# Access Compliance Report

## Public Rights-of-Way

### (Curb Ramps)

Intersection ID: 47999		Main Street: REDBRIDGE_TL		Cross Street: CLYMER_CT		Location: NE			
ADA ID: BC77F7F94A53		Ramp Type: PerpDiag		Initial Pass/Fail: Fail		Overall Compliance: No		Severity Score: 22.5	
Codes/Mitigation Info/Possible Solution					Field Measurements/Component Compliance

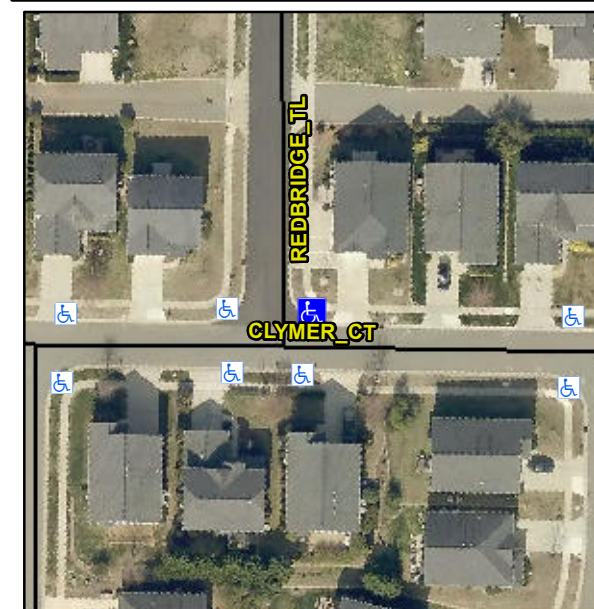
**Not Found, R304.5.1, R304.2.2, R304.5.3**

Compliance	Description	Data	Compliance	Description	Data
N/A	Ramp Length (in)	71.5	No	Ramp Slope (%)	9.2
No	Ramp Width (in)	47.0	No	Ramp XSlope (%)	4.2
N/A	Flare Type LT	N/A	N/A	Flare Type RT	N/A
N/A	Flare Slope LT (%)	N/A	N/A	Flare Slope RT (%)	N/A
N/A	Flare Traversable LT?	N/A	N/A	Flare Traversable RT?	N/A
N/A	Landing Length (in)	N/A	N/A	DWS Provided?	N/A
N/A	Landing Width (in)	N/A	N/A	DWS Contrast?	N/A
N/A	Landing Slope (%)	N/A	N/A	DWS Length (in)	N/A
N/A	Landing X Slope (%)	N/A	N/A	DWS Full Width?	N/A
N/A	Landing Curb? (Y/N)	N/A	N/A	DWS Offset (in)	N/A
N/A	Shared Landing?	N/A			
N/A	Gutter Ponding?	N/A	N/A	Gutter Slope (%)	N/A
N/A	Gutter Lip Ht (in)	N/A	N/A	Gutter X Slope (%)	N/A
N/A	Painted X Walk1?	No	N/A	Painted X Walk2?	No
	X Walk 1 Direction	To W		X Walk 2 Direction	To S
N/A	X Walk 1 Width (in)	N/A	N/A	X Walk 2 Width (in)	N/A
	X Walk 1 Slope (%)	3.5		X Walk 2 Slope (%)	0.7
	X Walk 1 X Slope (%)	1.6		X Walk 2 X Slope (%)	4.5

**Remove & Replace Curb Ramp With Two New Directional Ramps or Equivalent.**
